MODIFICATION #2
WEST LILAC ROAD OVER I-15 BRIDGE
DEPARTMENT OF PUBLIC WORKS

**Request for a
Modification to a Road Standard
and/or to Project Conditions**

Project Number: TM 5571/5572 Date of Request: Sep. 12, 2012

ATTACHMENT 1

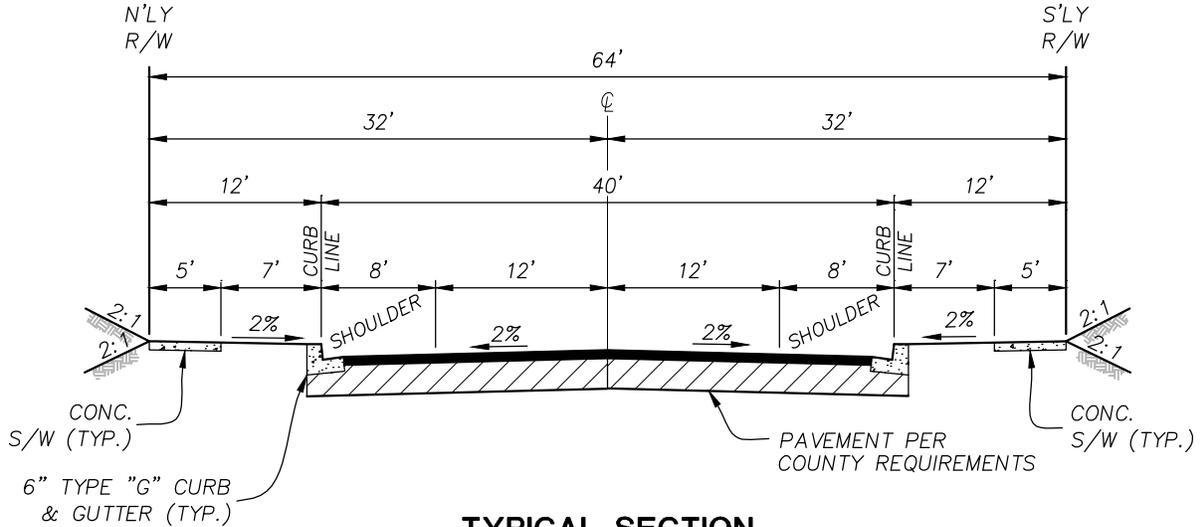
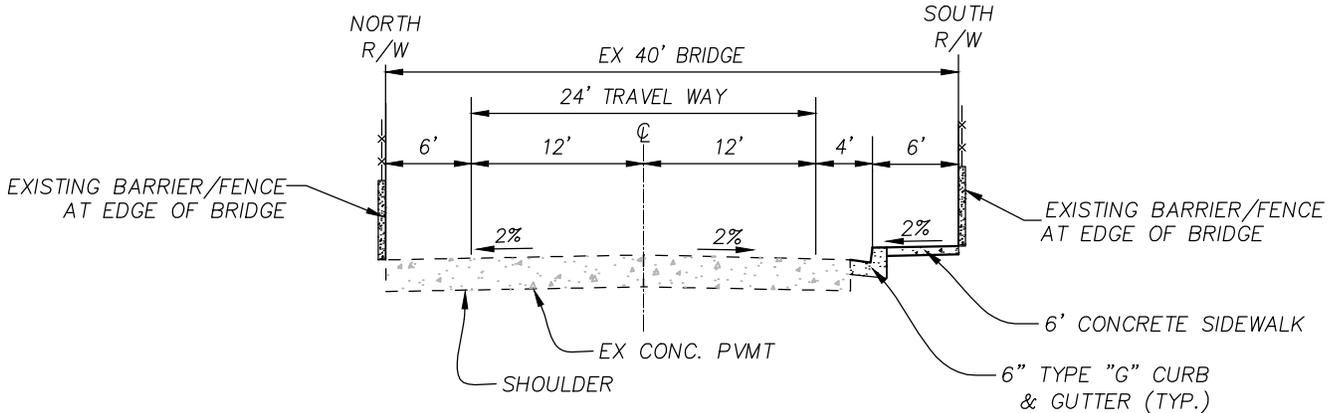
The standard road section for Light Collector Road 2.2C is 40'-54' wide curb to curb
width on 64'-78' r/w with a minimum design speed of 40 mph. The requested modification
to the road standard is to require no widening of the existing 40' wide West lilac Road
bridge over I-15 and allow only re-striping and the addition of curb, gutter and sidewalk
on one side of the road (see attachment 1).

ATTACHMENT 2
LILAC HILLS RANCH: LIGHT COLLECTOR 2.2C
MODIFICATION TO ROAD STANDARDS

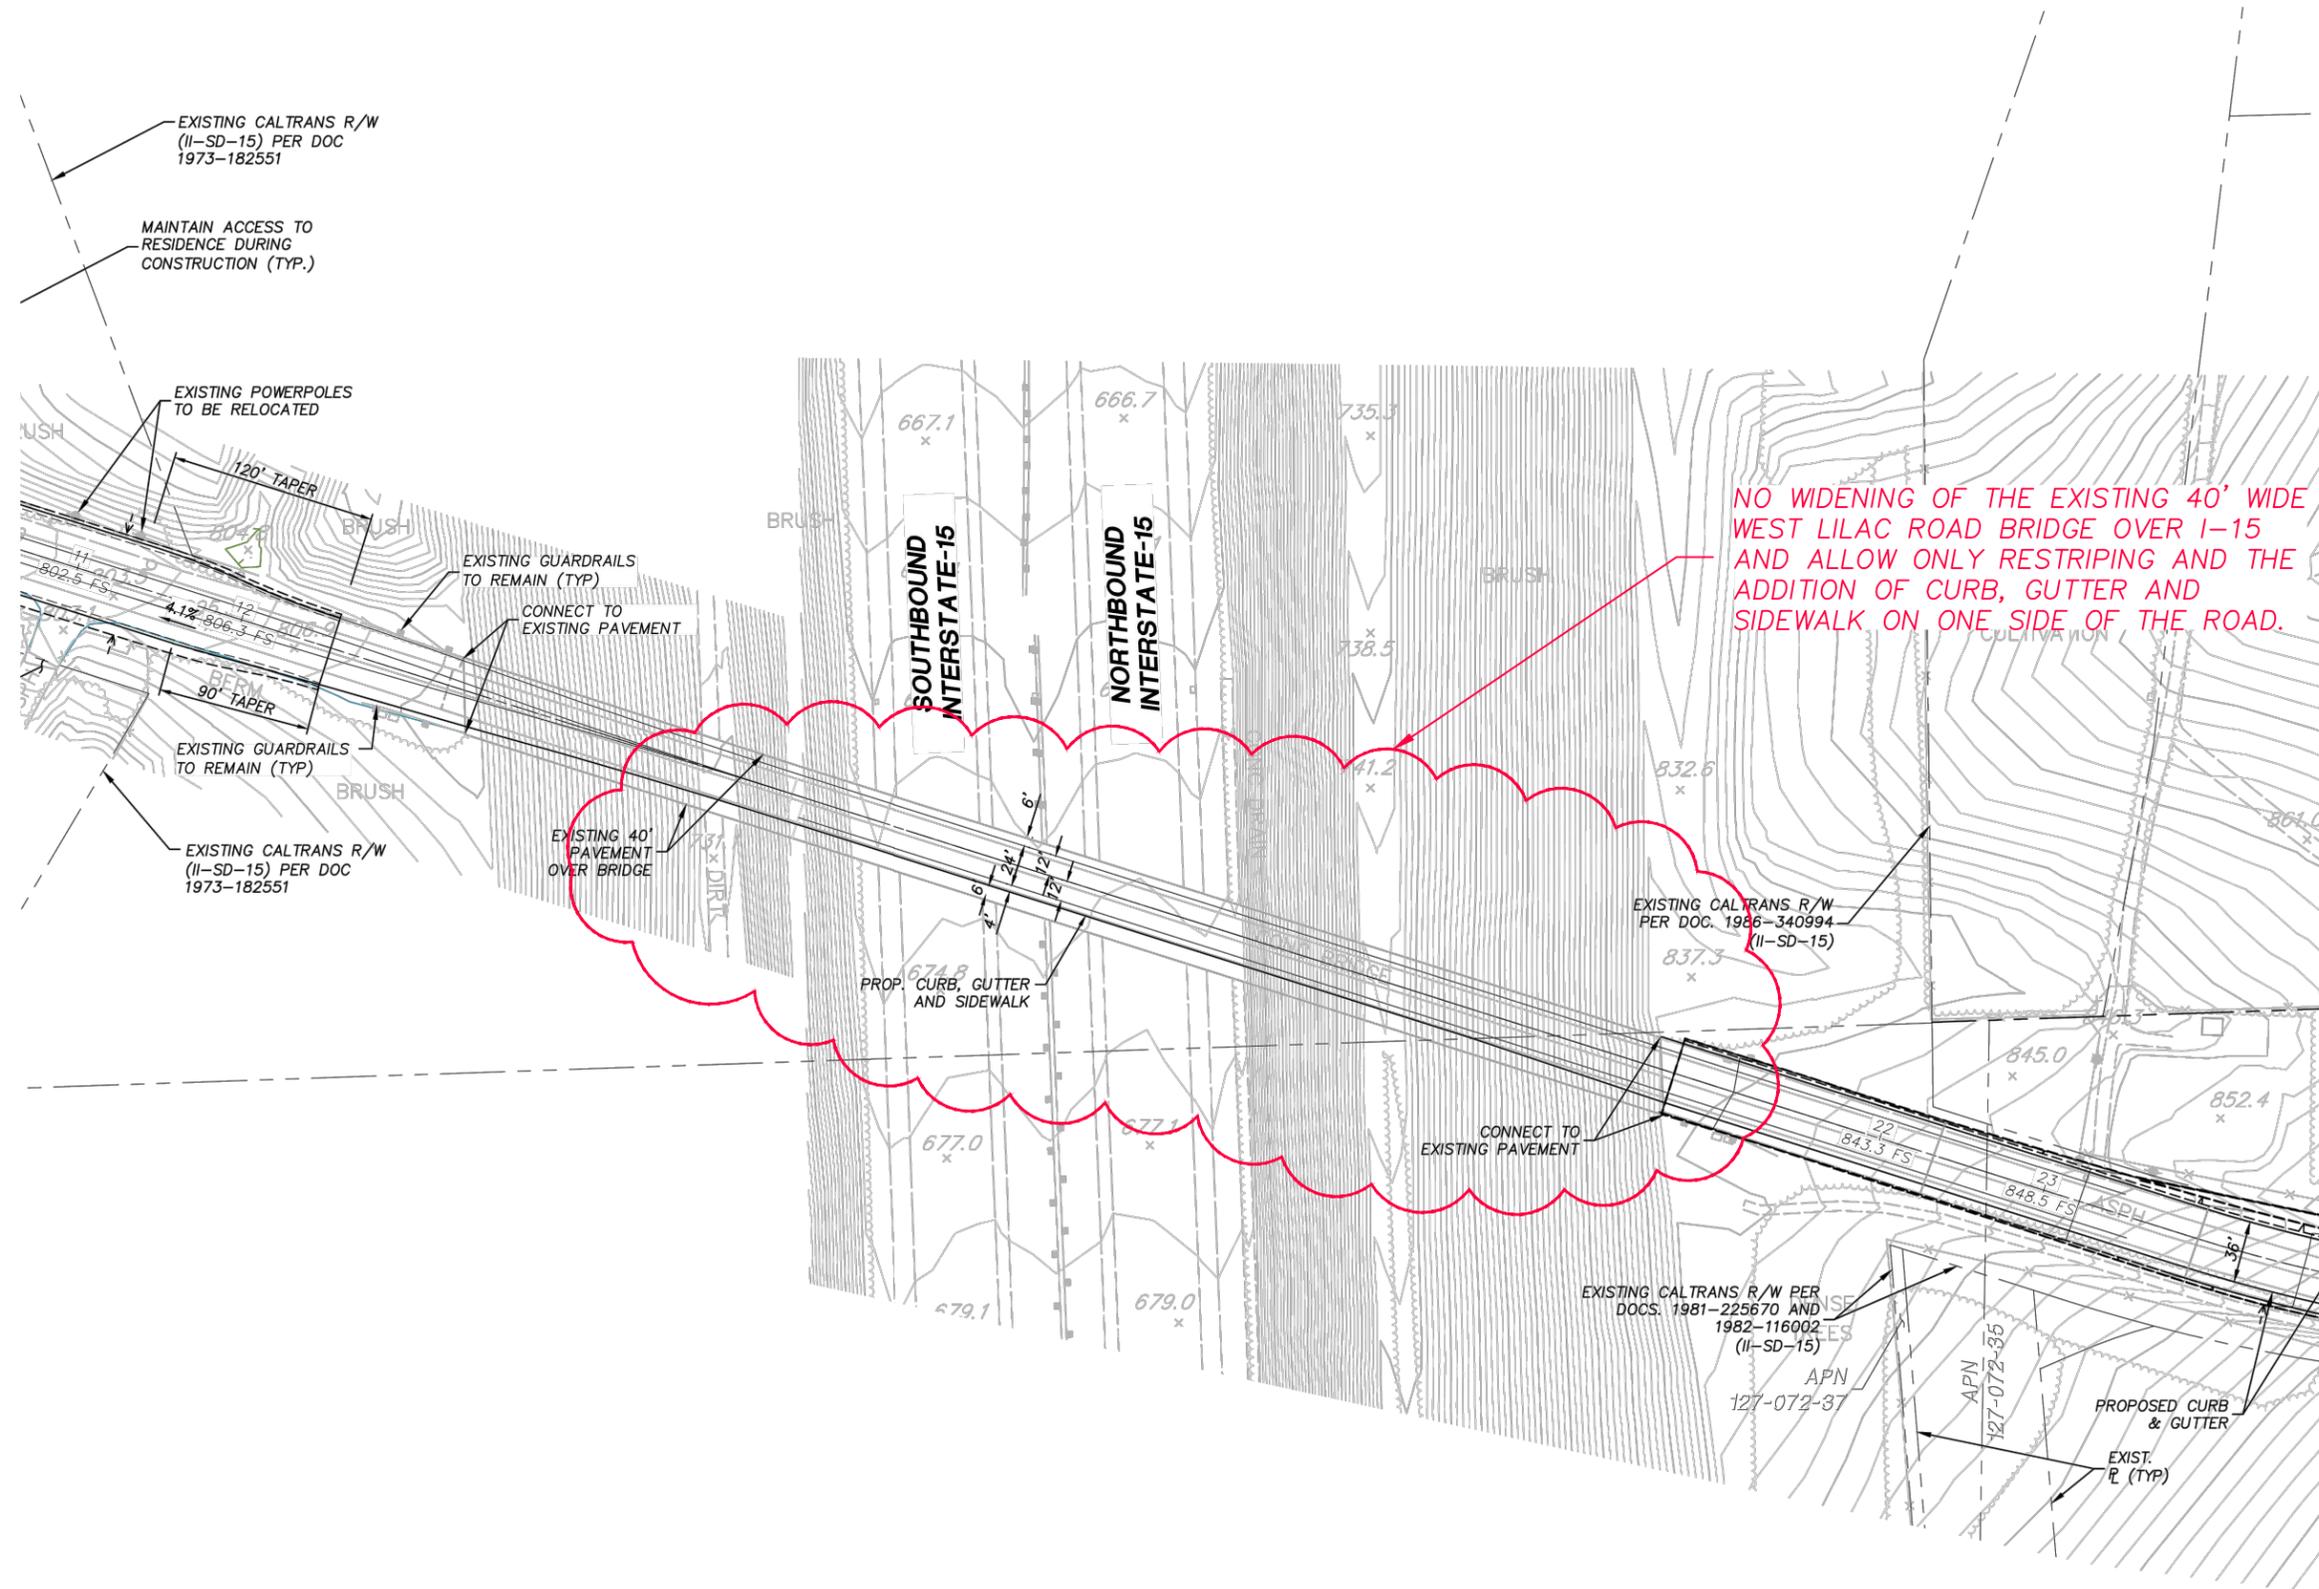
The existing 40' wide bridge section has a 24' travel way with 8' shoulders on each
side. A proposed widening of the bridge would be extremely expensive, extremely
disruptive to anyone that uses West Lilac Road & I-15, and would alter the beauty and
historic nature of the bridge (see attachment 2). The modified road would also allow
for safer pedestrian traffic over the bridge.

ATTACHMENT 3 WITH MODIFICATION #2 BRIDGE OVER INTERSTATE 15

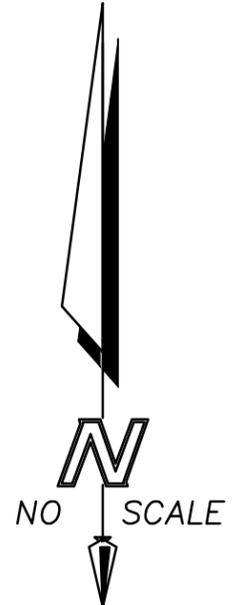
NO WIDENING OF THE EXISTING 40' WIDE WEST LILAC ROAD BRIDGE OVER I-15 AND ALLOW ONLY RESTRIPING AND THE ADDITION OF CURB, GUTTER AND SIDEWALK ON ONE SIDE OF THE ROAD.
